Int. Appl. No.: PCT/US02/15387

U.S. Appl. No.: 10/712,060

Amdt. dated: July 19, 2005

Amendments to the Figures:

FIG. 1a

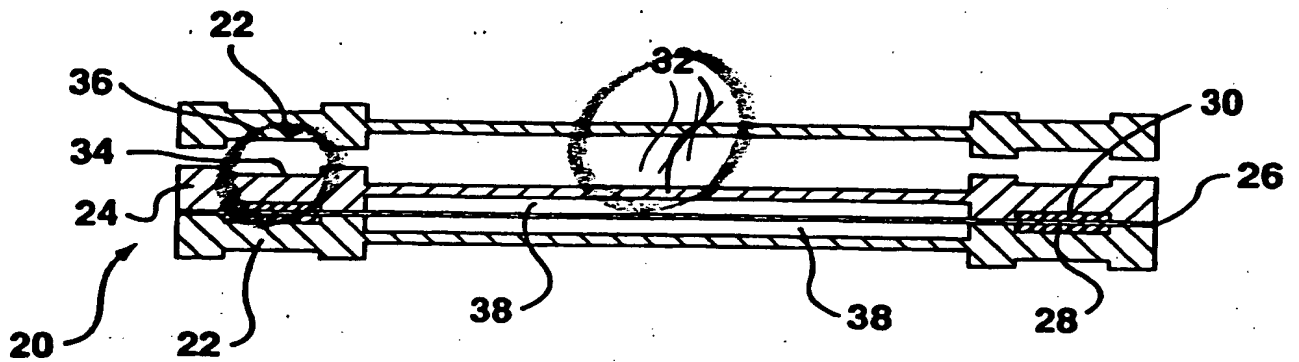
With respect to the drawings, amendments are being made to Figures 1a-e, 2, 7-12, and 17. In Figures 1 and 2, the amendments to the lead lines are intended merely to ensure that these drawings are wholly consistent with the specification and to aid in understanding the drawings. In Figure 7, the connection apertures have been labeled with reference numeral 160. In Figure 8, for consistency with Figure 7, the references

FIG. 9

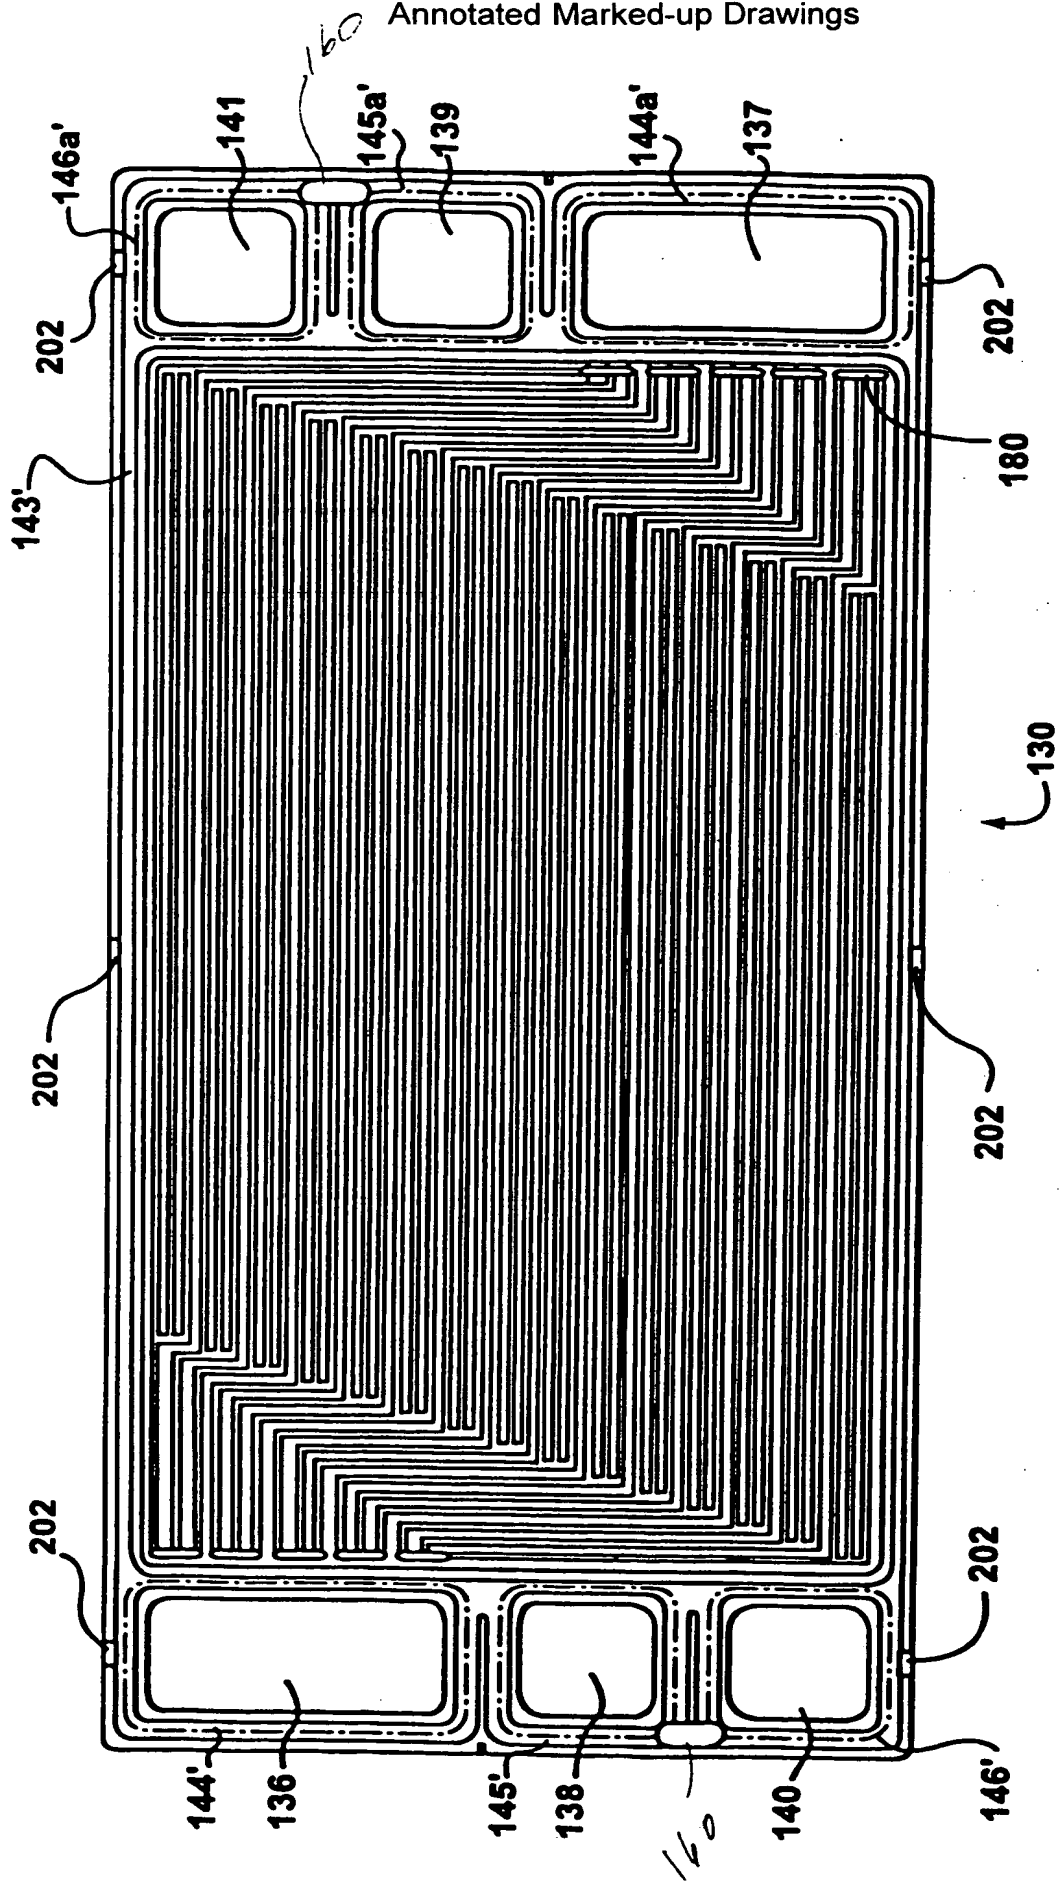
137, 139 and 141 now denote ports on the left hand side, while references 136, 138 and 140 denote ports on the right hand side. In Figure 9, the connection apertures have been labeled with reference numeral 160. In Figure 10, the reference numerals 182', 184' and 186' are, in effect, being switched with the reference numerals 182a', 184a' and 186a'. In Figure 11, at the right hand side reference numeral 160e has been amended to read 160ae and the reference 160e added on the left hand side; at the top 132 has been corrected to 192. In Figure 12, the sealing aperture has been labeled with reference numeral 160e. In Figure 17, the lead line for reference numeral 146 has been extended to point to the sealing groove to ensure that the drawing is wholly consistent with the specification. These amendments are simply intended to ensure consistent use with the reference numerals used in the Figures and the description and for clarity in the drawings.
